Date: 25/06/2019
Subject: New center bearing rubber cushion (50 Durometer Rubber)
Models: RPL 25 Series Centre Bearing Drivelines

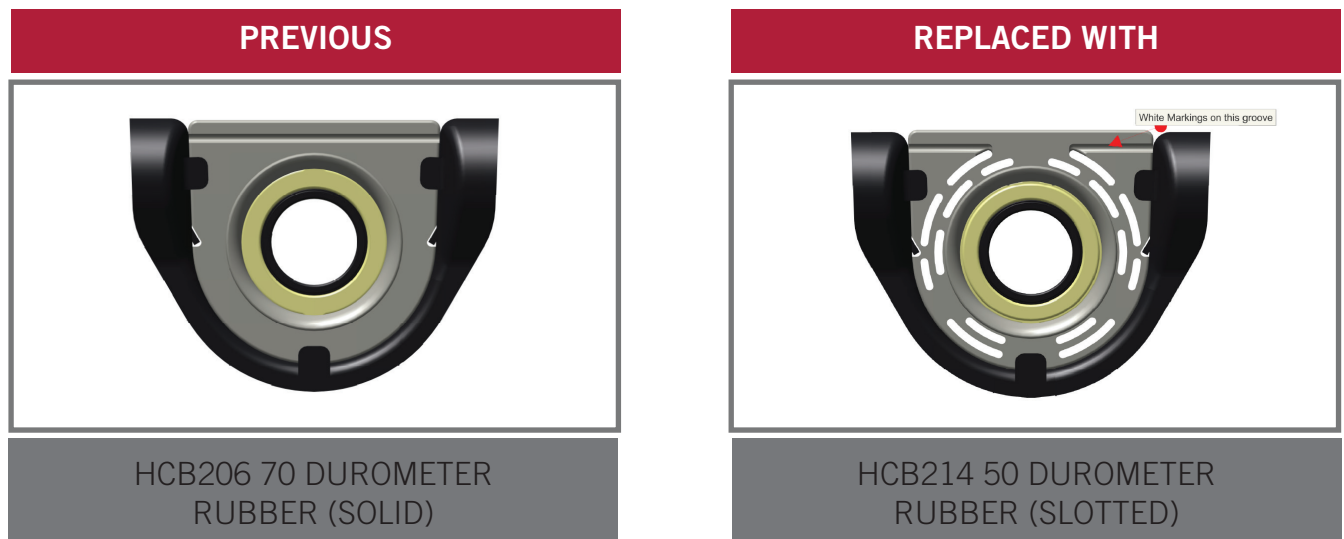
Meritor Australia would like to inform you of a change in the center bearing rubber cushion used in the RPL 25 Series Centre bearing drivelines. This change will reduce the risk of vibration resonance for chassis-driveline interaction in Kenworth trucks fitted with the RPL 25 drivelines.

This change will be effective on drivelines built from the 25th of June.

The driveline series number will change from 25RHC020B to 25RHC076B with the change in centre bearing.
